# Access Compliance Report Public Rights-of-Way (RR Crossings)

Intersection ID: 10031407	Main Street: MCALPINE_STATION_DR	Location: N/A
ADA ID: 41ECFC753BAB	Overall Compliance: No	Severity Score: 0.0
Codes/Mitigation Info/Possible Solution		Field Measurements/Component Compliance

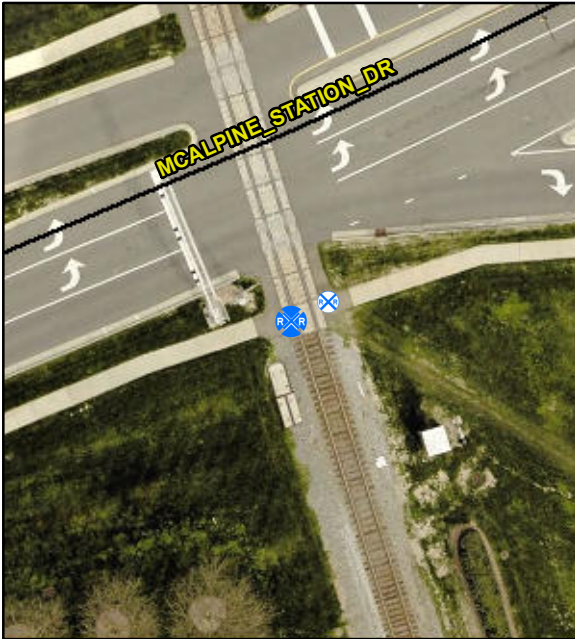
Compliance	Description	Data
No	DWS Provided?	No
N/A	DWS Contrast?	No
N/A	DWS Width (in)	No
N/A	DWS Length (in)	N/A
N/A	DWS Offset (in)	N/A
No	Pedestrian Gate?	No
N/A	DWS Outside Gate?	No
N/A	Rail Type?	Freight
No	Flangeway Gap (in)	3.0
Yes	Sidewalk Width (in)	60.0

**Install Detectable Warning System.  
Provide Pedestrian Gate. Remove &  
Replace Walking Surface Adjacent  
to Rail.**
